TITLE:  
 ITEM NO:  
 DESC.: PLAN, ELEVATIONS, DETAIL  
 DESC.: RECEPTION DESK  
 By: PD Scale: As Noted Job No. Dwg. No.  
 Status: In Submittal Review Date: 2018-10-10 08-01

TITLE:  
ITEM NO:  
DESC: SECTIONS, DETAILS  
DESC: RECEPTION DESK

01 ELEVATION  
 SCALE: 1/2" = 1'-0"  
 Archt Ref.: 1/A-665.00

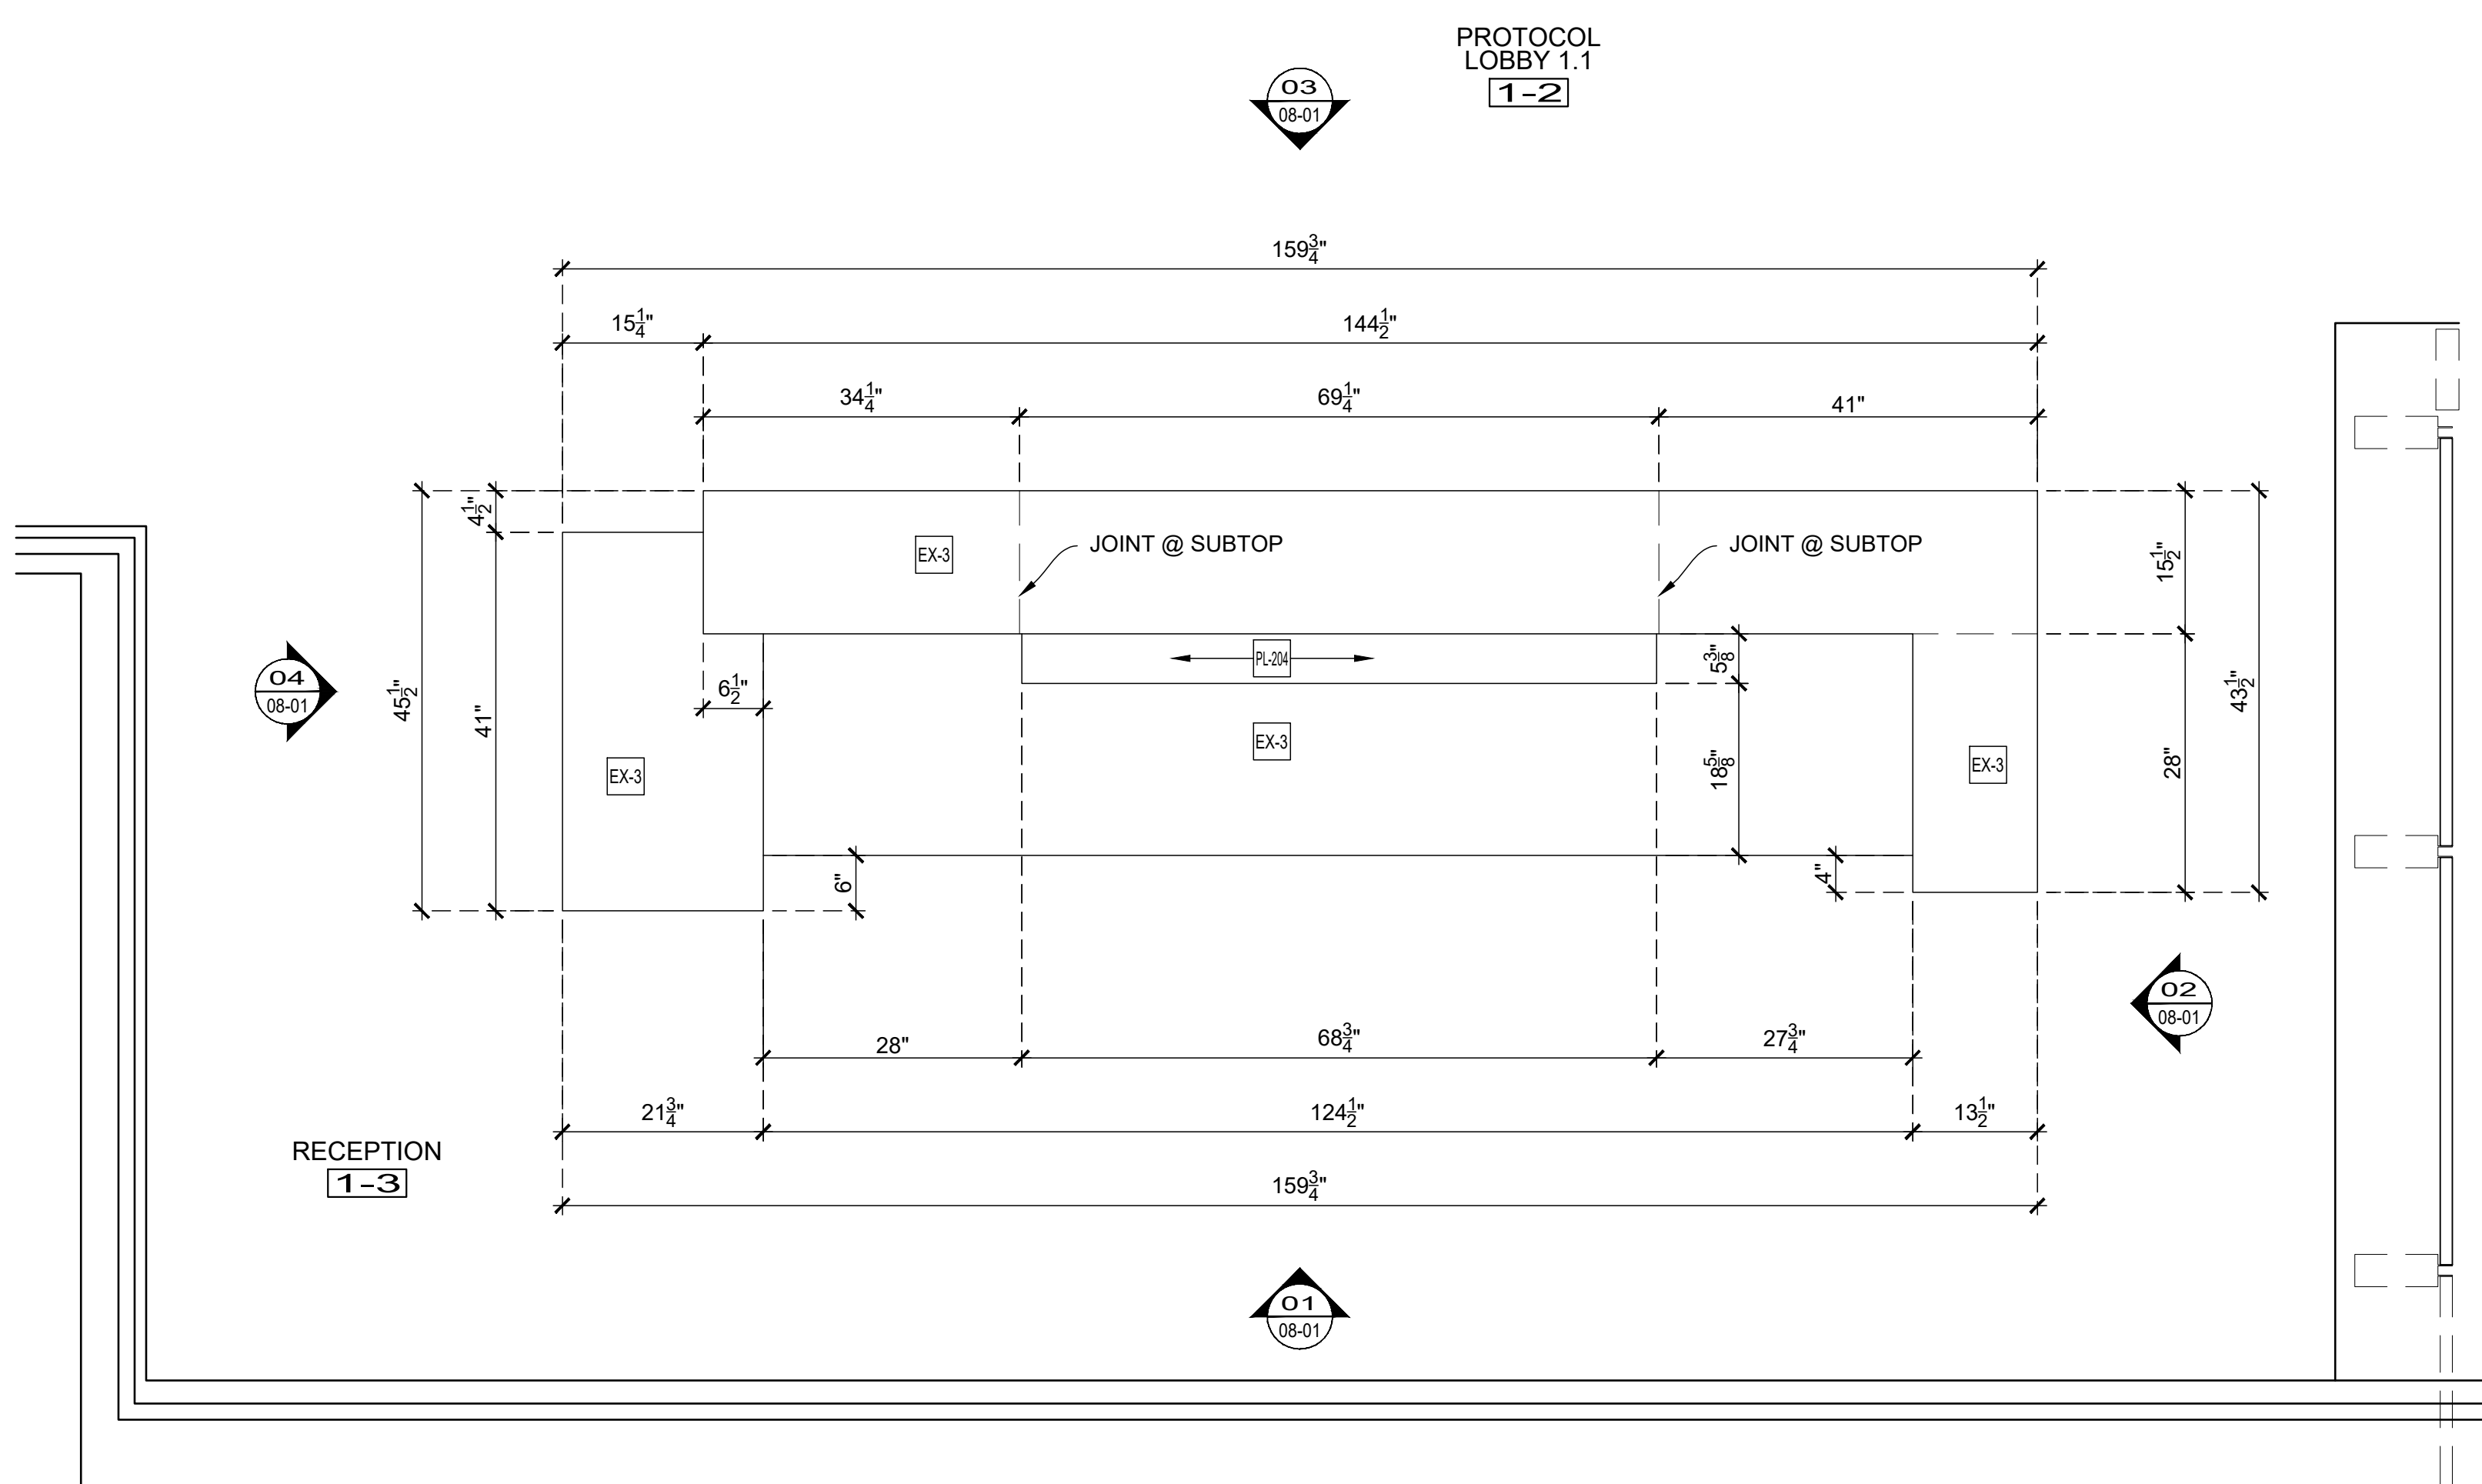
ARCHITECT NOTE:  
 AS PER COUNTERTOP WIDTH WE SUGGEST SUPPORT LEG. PLEASE CONFIRM

ARCHITECT NOTE:  
 PLEASE VERIFY DIMENSION AS PER ELEVATION (1/A-665.00) & LONG SECTION (2/A-666.00) IS 2'-4 1/2" BUT AS PER VERTICAL SECTION (3,4,5,7/A-666.00) IS 2'-4 3/8"

ARCHITECT NOTE:  
 PLEASE PROVIDE MODEL & MANUFACTURE OF PULL

ARCHITECT NOTE:  
 PLEASE VERIFY IF GROMMET REQ'D. IF REQ'D PLEASE PROVIDE MODEL, MANUFACTURE, QUANTITY AND LOCATION

05 PLAN  
 SCALE: 1/2" = 1'-0"  
 Archt Ref.: A-101.00

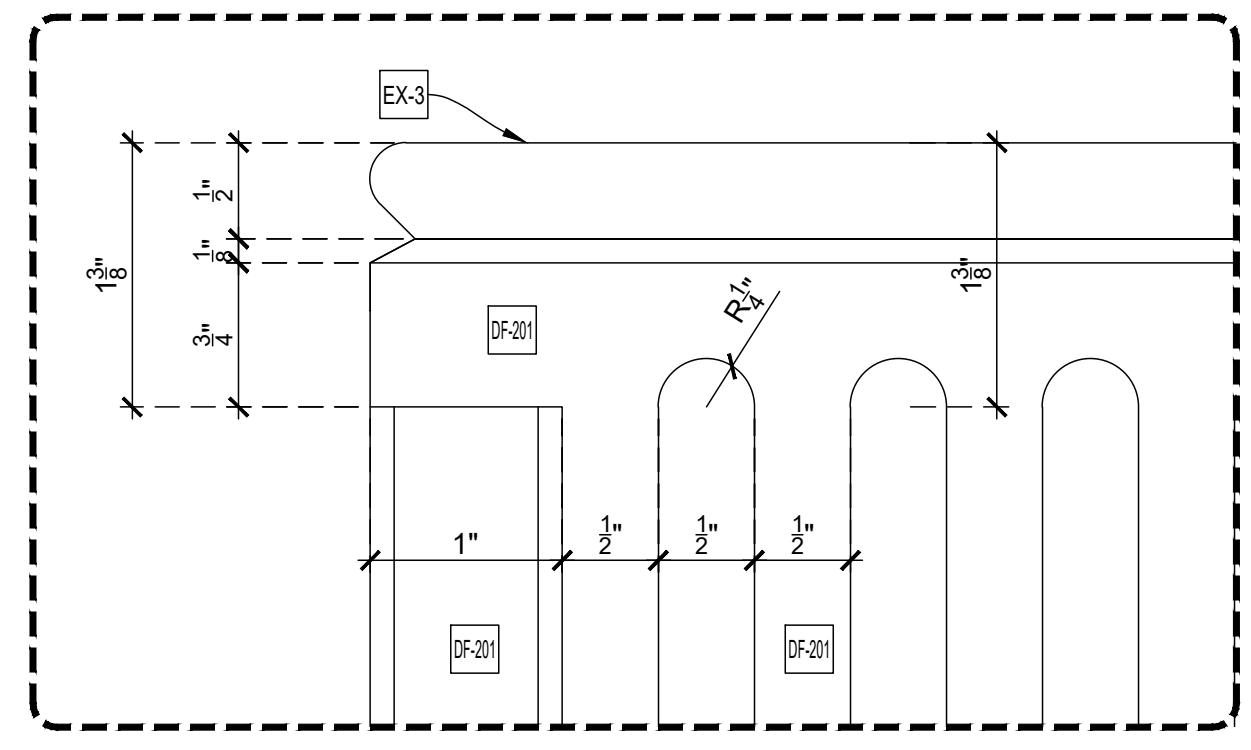
ARCHITECT NOTE:  
 PLEASE PROVIDE SPECIFICATION AND CUTSHEET FOR COORDINATION

**E-4 VERTICAL SECTION**  
SCALE: 1-1/2" = 1'-0"  
Arch't Ref.: 3/A-666.00

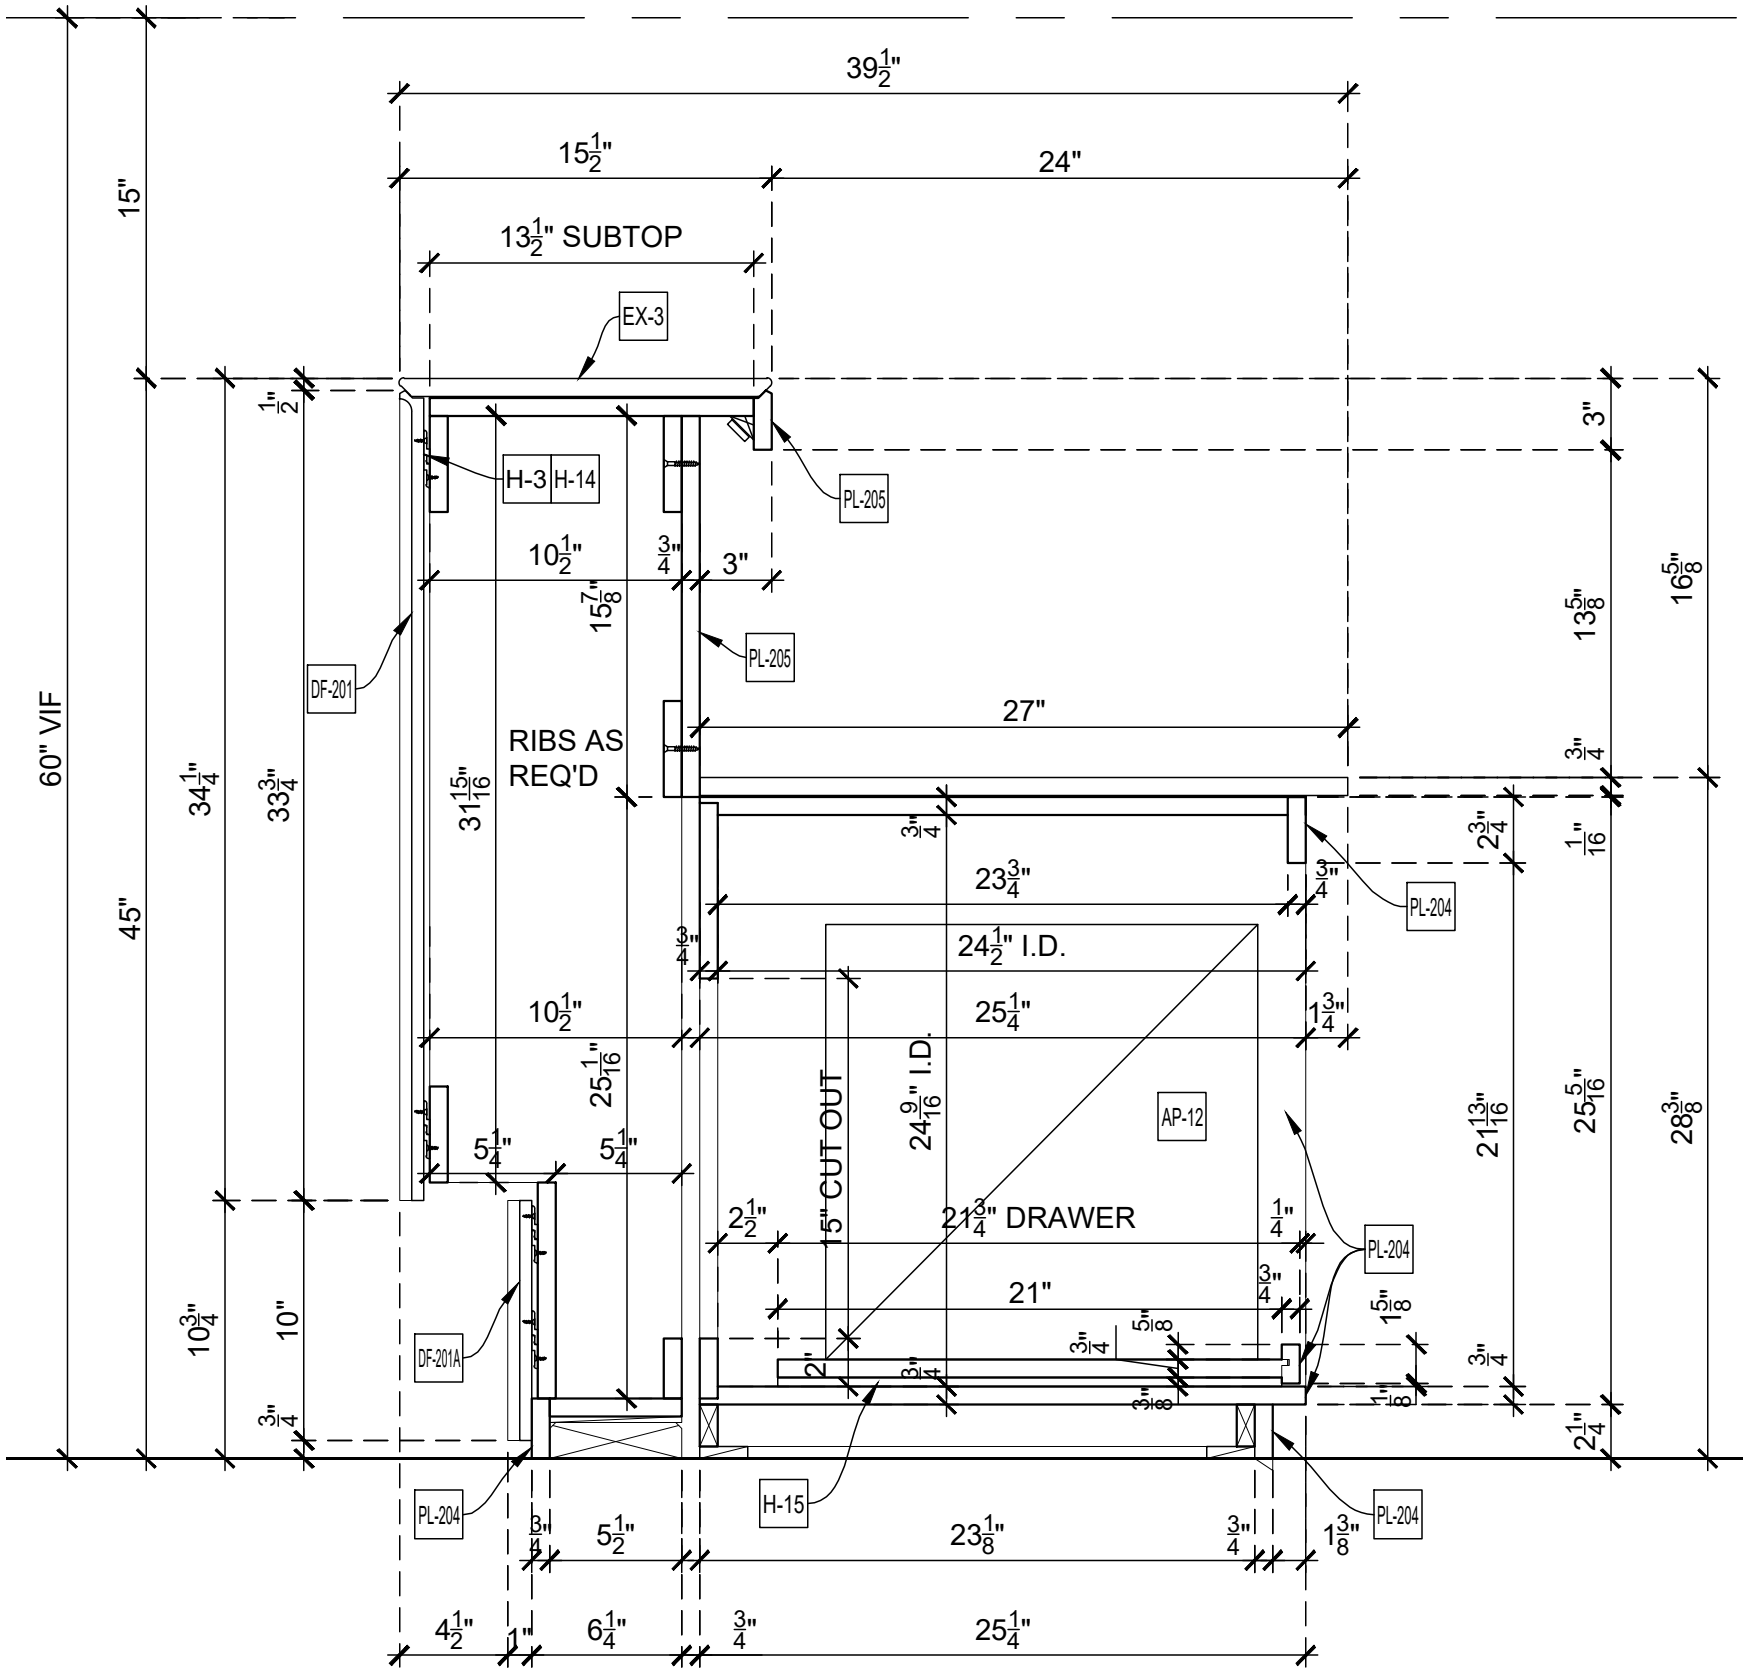
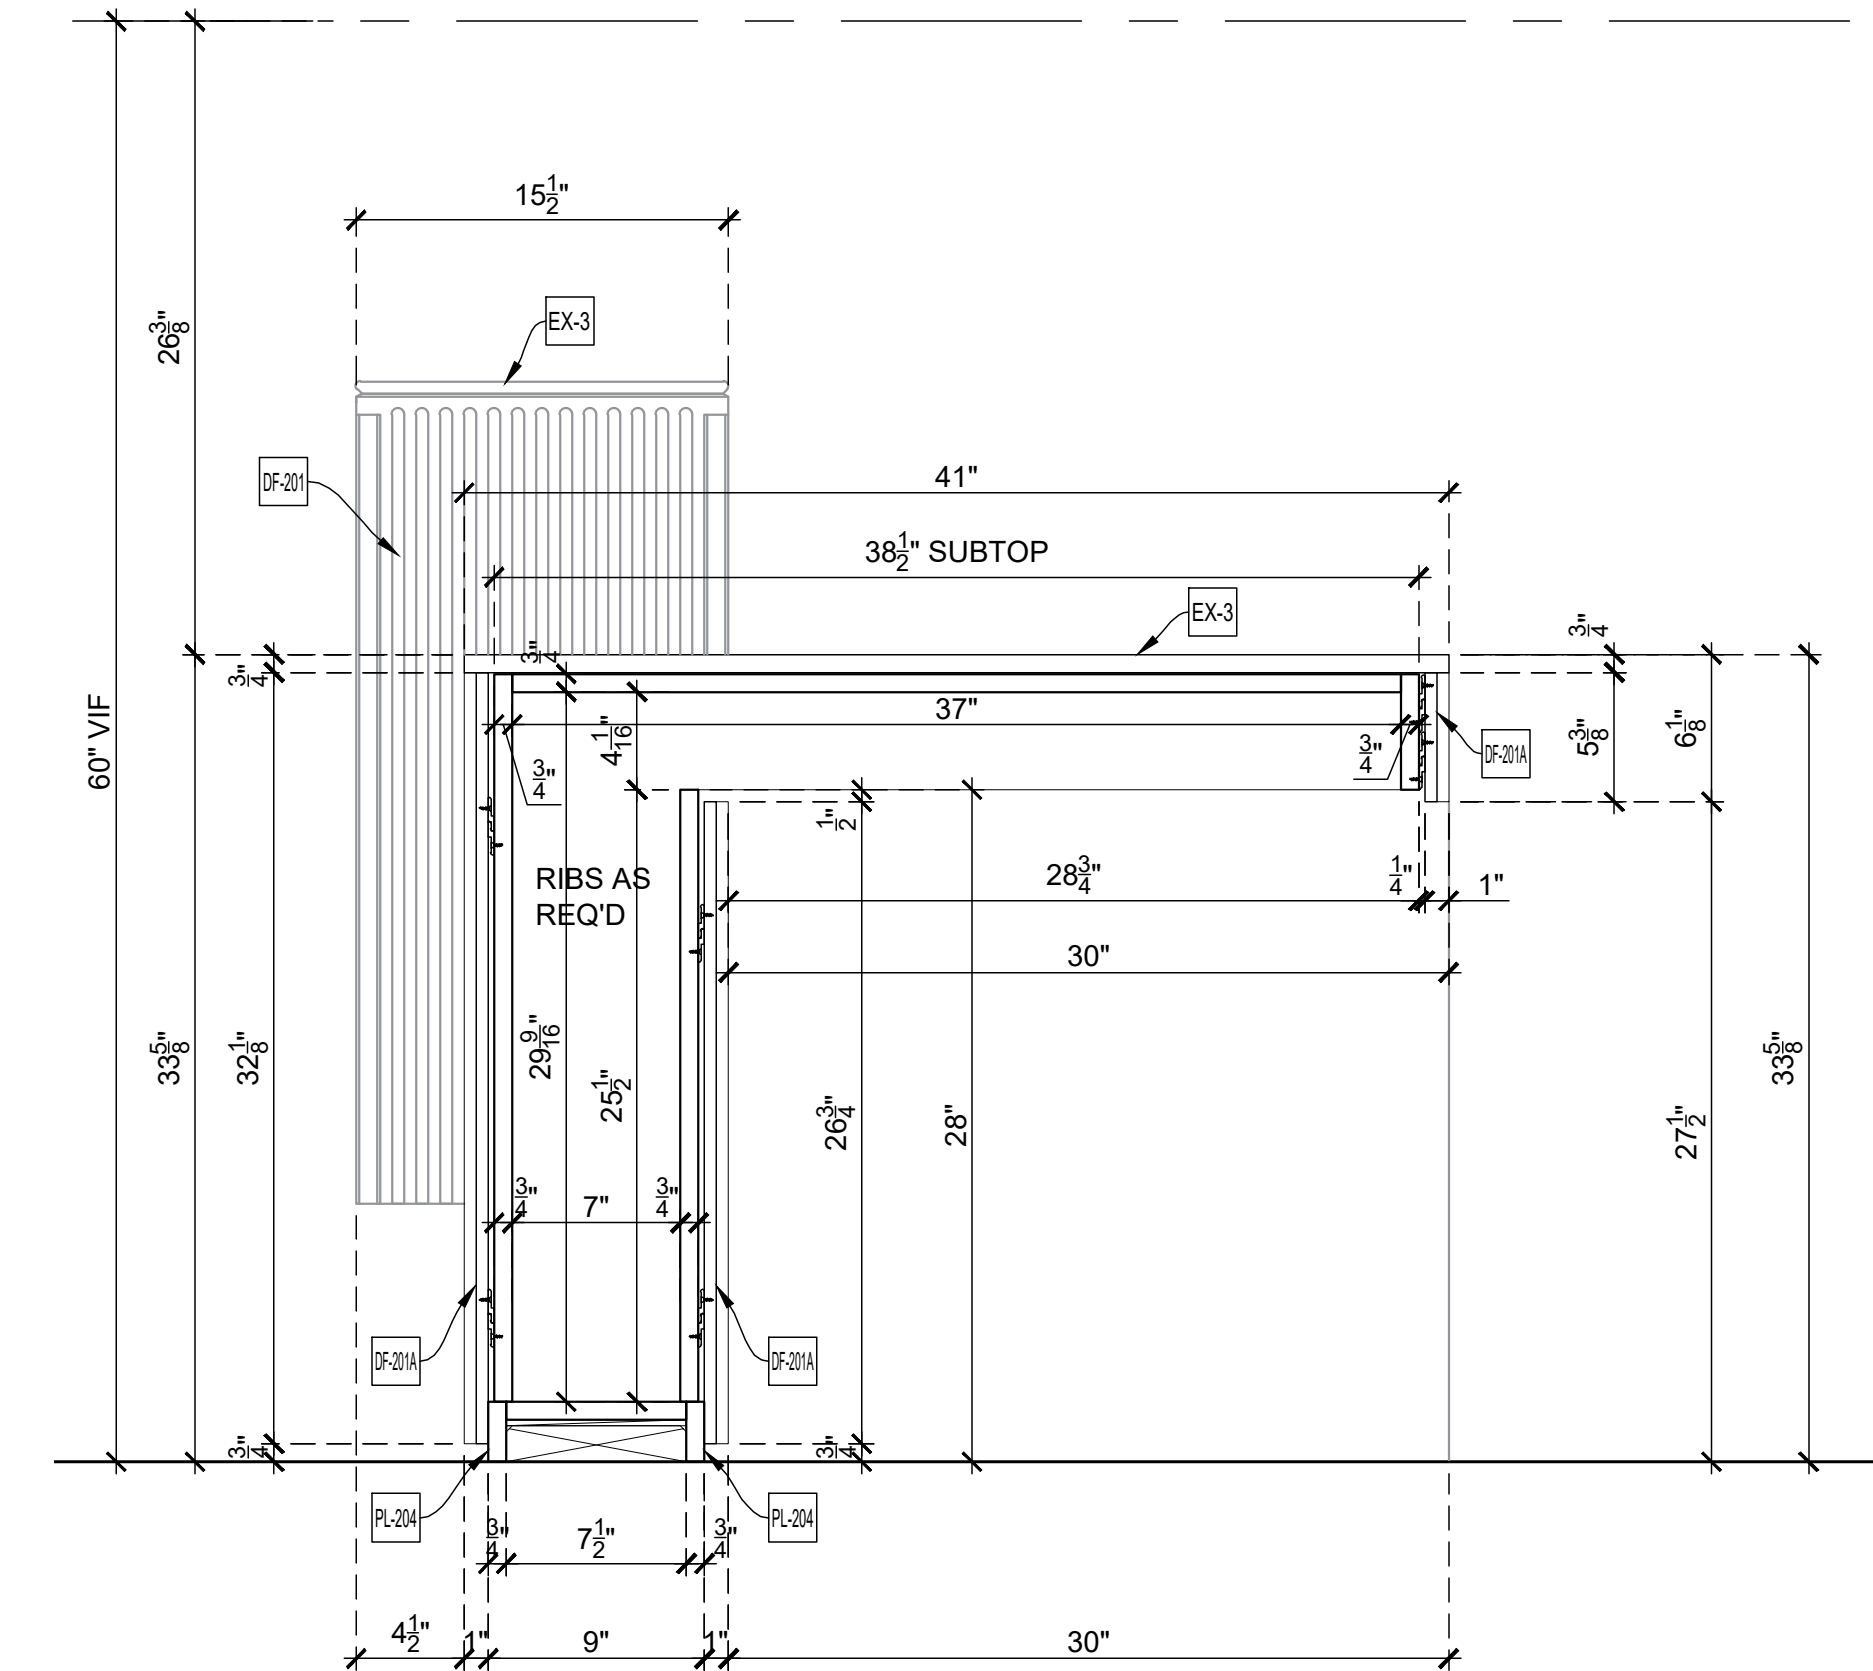
**ARCHITECT NOTE:**  
PLEASE PROVIDE INTERIOR FINISH
